INNER WEST COUNCIL

DEVELOPMENT ASSESSMENT REPORT

Application No.	DA201900162
Address	11A Tupper Street, Enmore
Proposal	To demolish the existing dwelling house and construct a four storey boarding house containing 21 rooms above basement parking.
Date of Lodgement	20 May 2019
Applicant	Emag Apartments Pty Ltd
Owner	Tupper Street Holdings Pty Ltd
Number of Submissions	22
Value of works	\$2,944,776
Reason for determination at Planning Panel	More than 10 submissions in objection
Main Issues	Design incompatible with the character of the local area Streetscape and design Inadequate boundary setbacks Residential amenity Inadequate internal amenity Landscape and trees Car and bicycle parking Disabled access and facilities Waste management facilities
Recommendation	Refusal
Attachment A	Recommended reasons of refusal
Attachment B	Plans of proposed development
Attachment C	Conditions in the circumstance the application is approved

ELEVATIONS

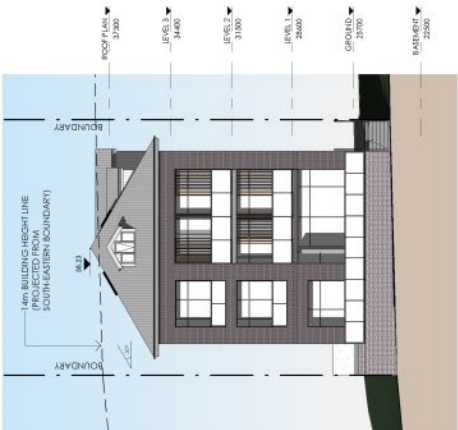
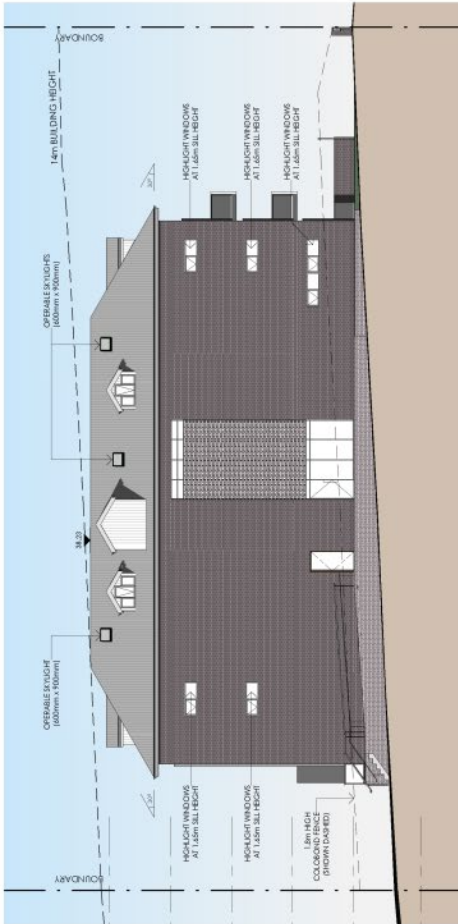
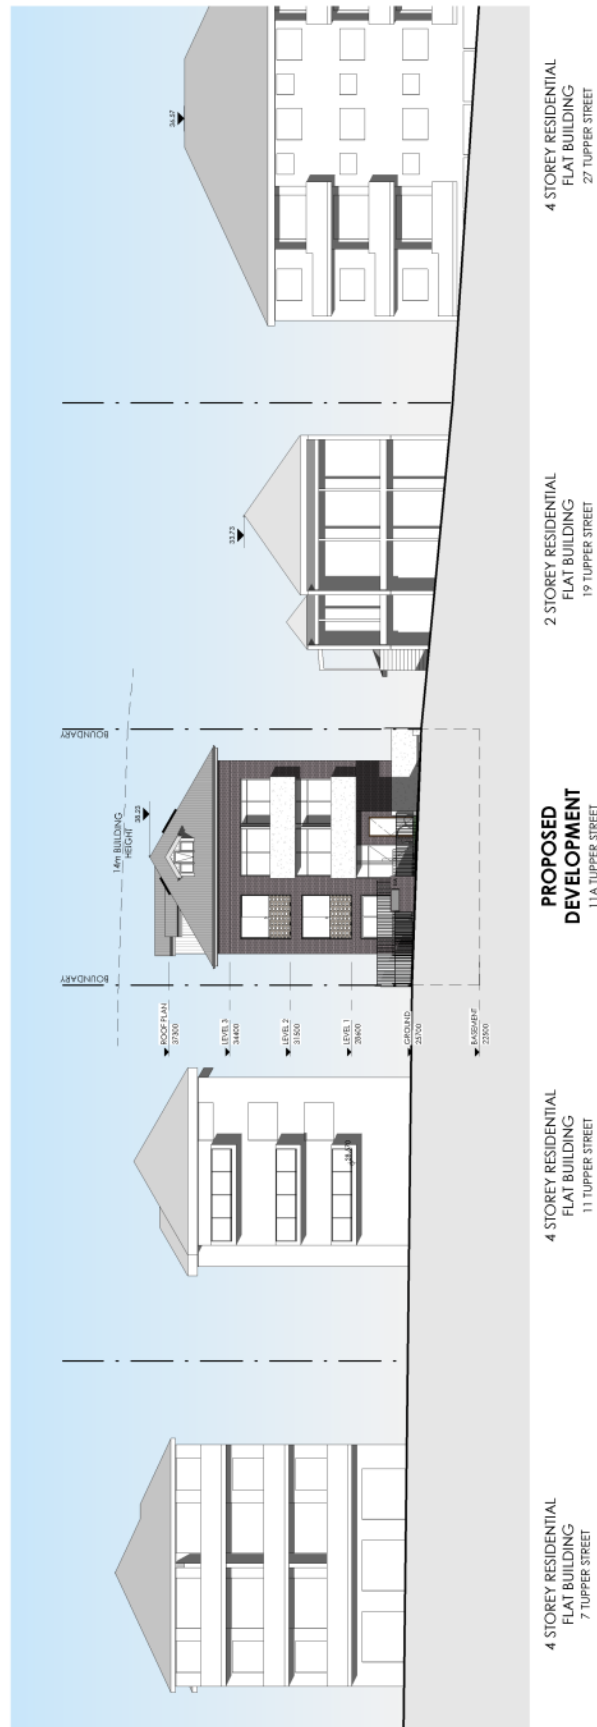
Part 2.1.3.6 Detailing	Contemporary materials can be joined together in ways that create articulation of form and texture of surfaces to provide visual interest.	The long blank side walls are predominately brick material with little articulation. The lack of texture will exacerbate the visual bulk and scale and vertical built form of the development when viewed from the adjoining properties.

1 WINTER SOLSTICE - 10AM
1 : 500

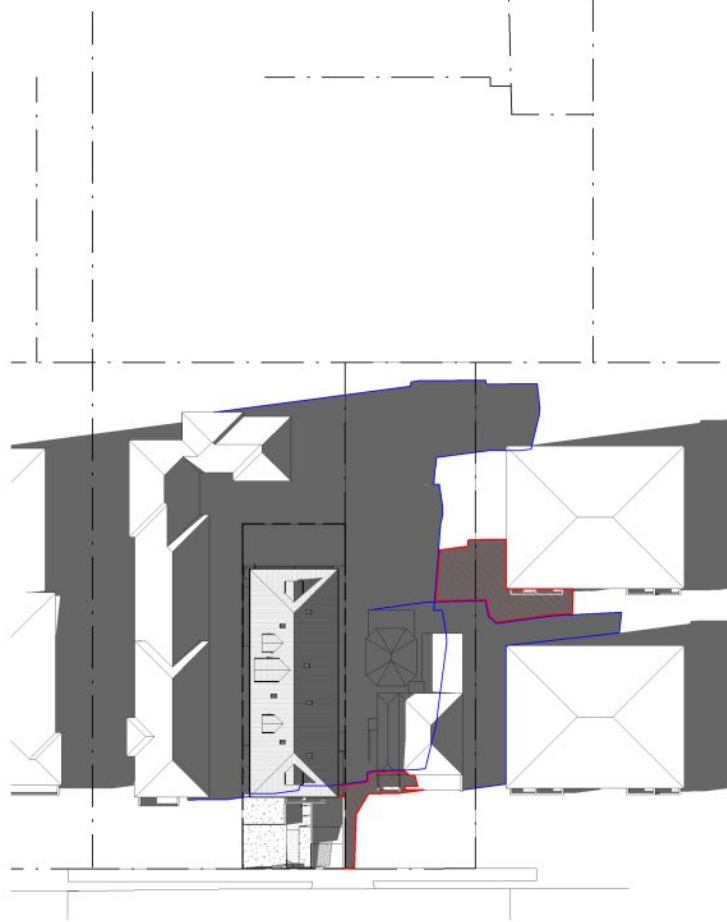
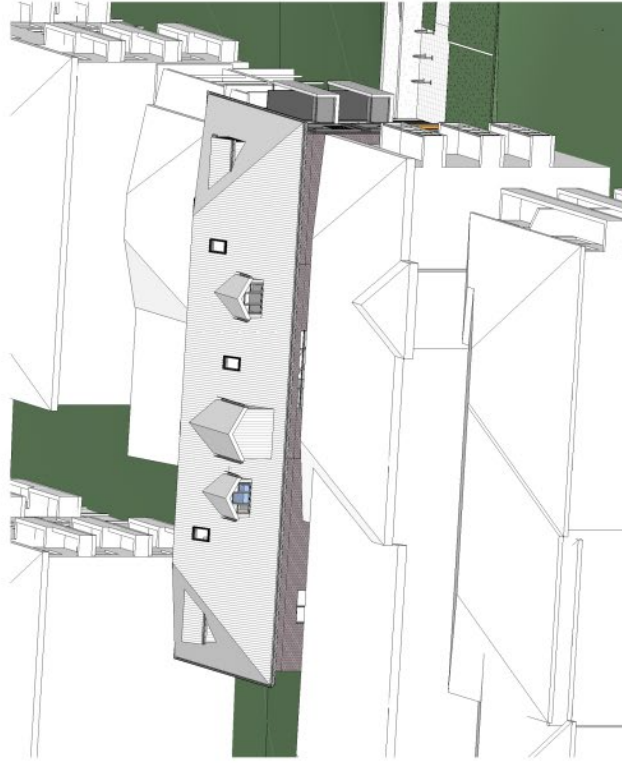
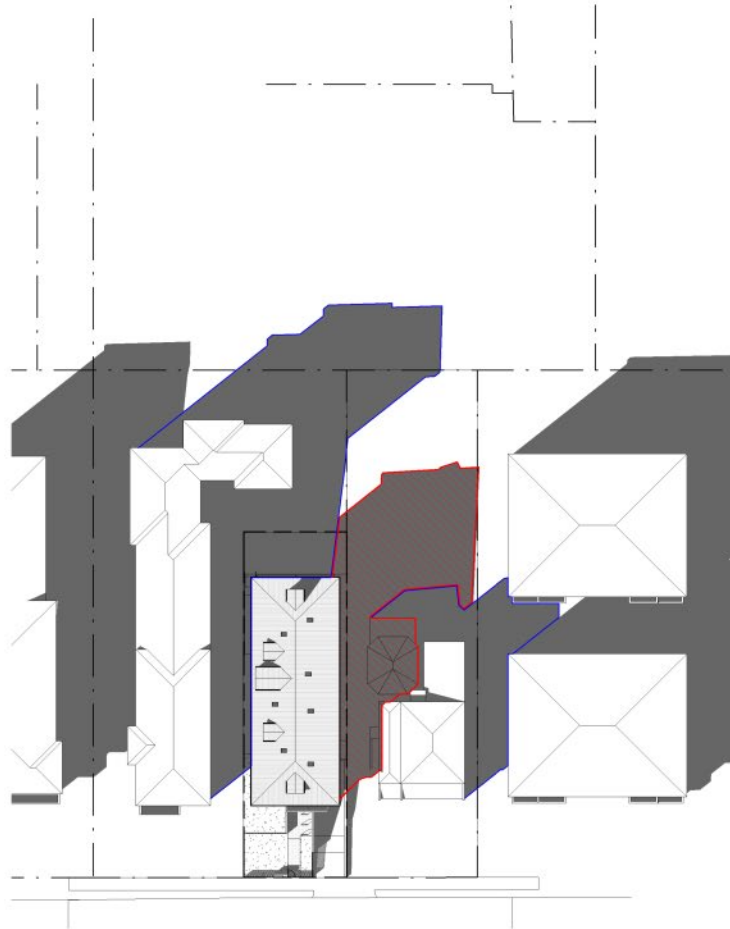
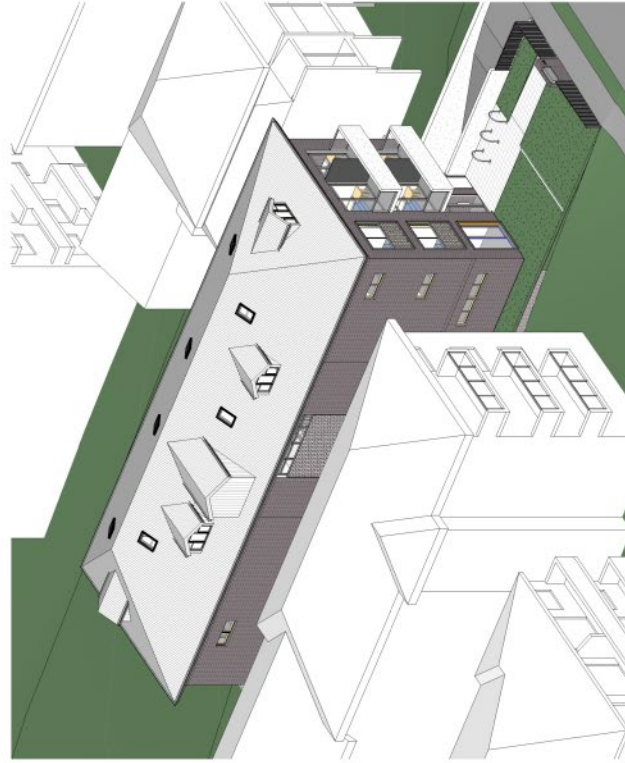
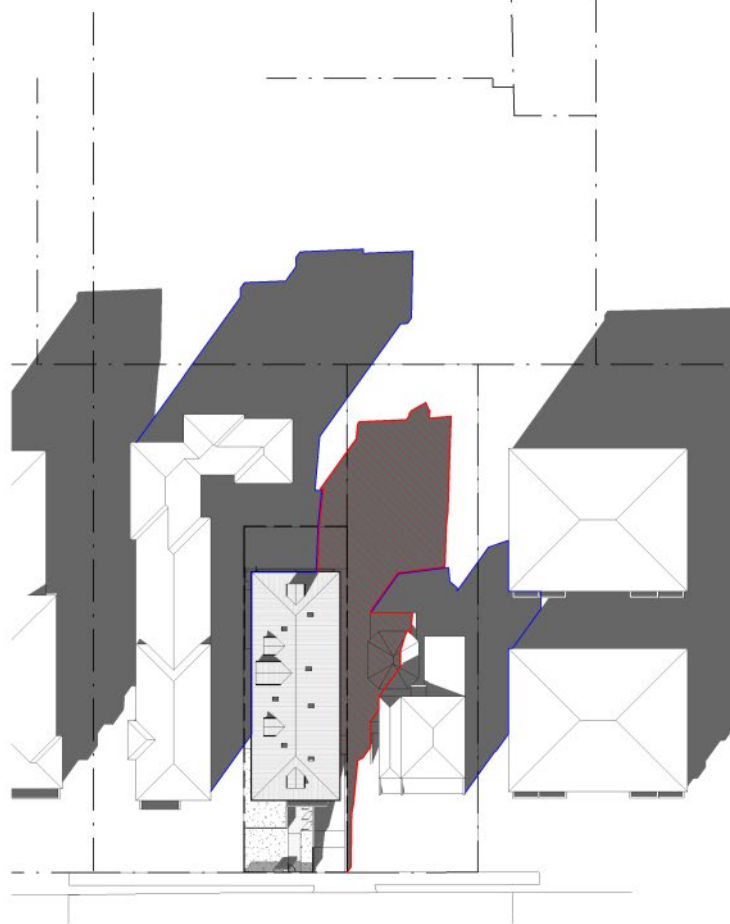
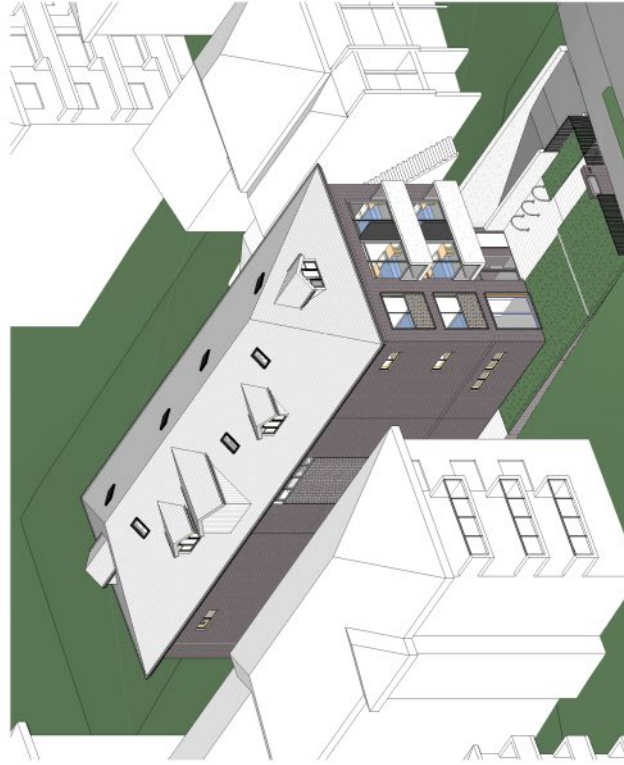
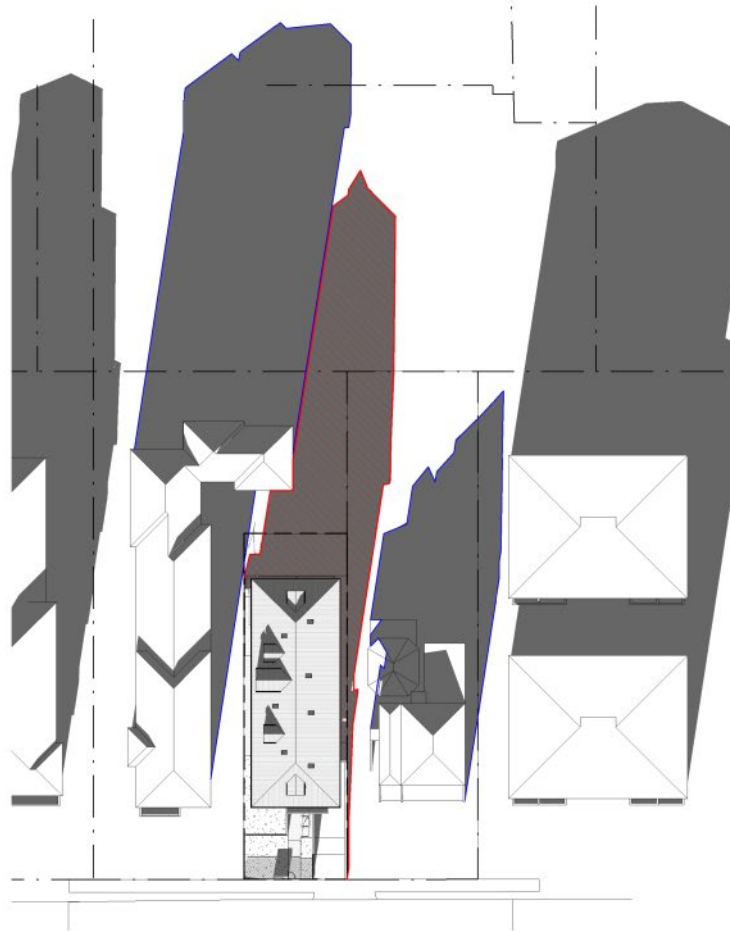
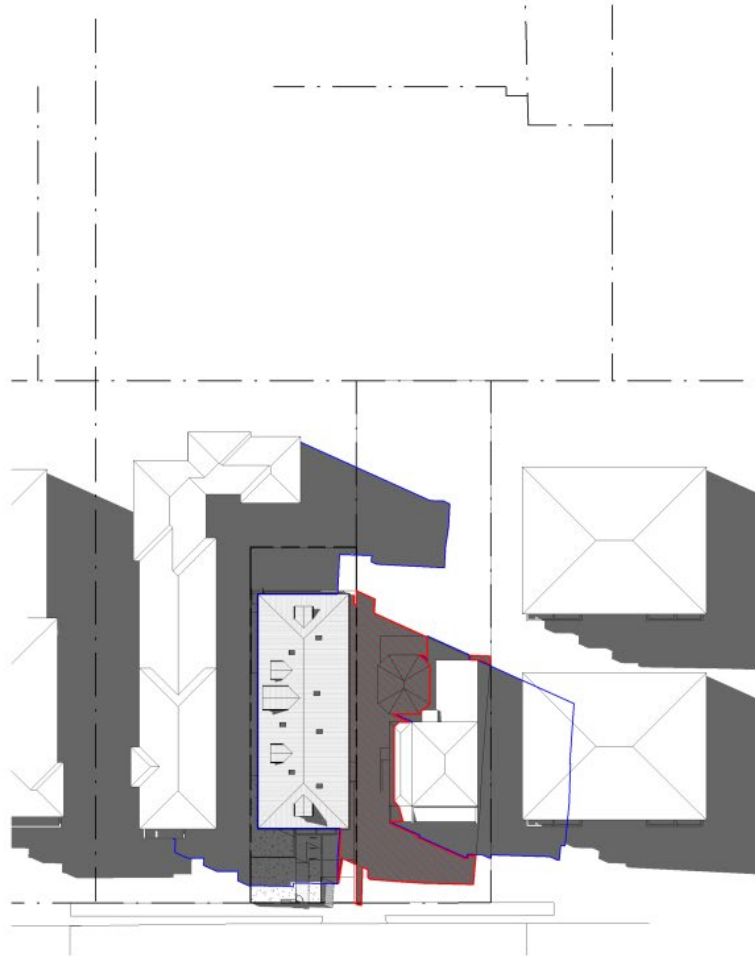
The shadow plans and the winter sun's eye diagrams submitted with the DA illustrate the windows to rooms 06, 07, 08, 13, 14, 15, 20, 21 and 22, which equates to 40 percent of the total rooms, receive a minimum two hours to more than 50% surface area. The proposal therefore does not comply with the minimum solar access requirements. The proposal is considered to not afford adequate amenity for future occupants having regard to the proposed design and the inadequate room sizes.

Part 2.7.2 requires shadow diagrams in plan and elevation view of existing and proposed overshadowing for June 21 at hourly intervals between 9.00am and 3.00pm. The Applicant's shadow diagrams submitted with the DA do not clearly delineate between the existing and proposed overshadowing to enable a proper assessment of the shadow impacts generated by the proposal. The Survey Plan submitted with the DA shows three windows along the northern elevation at 19 Tupper Street to the south. The SEE submitted with the DA states these windows are not living areas. However, no elevation shadow diagrams have been submitted to confirm the affected window types at 19 Tupper Street. Also, the SEE fails to address the shadow impacts to the existing verandah at the rear elevation of 19 Tupper Street.
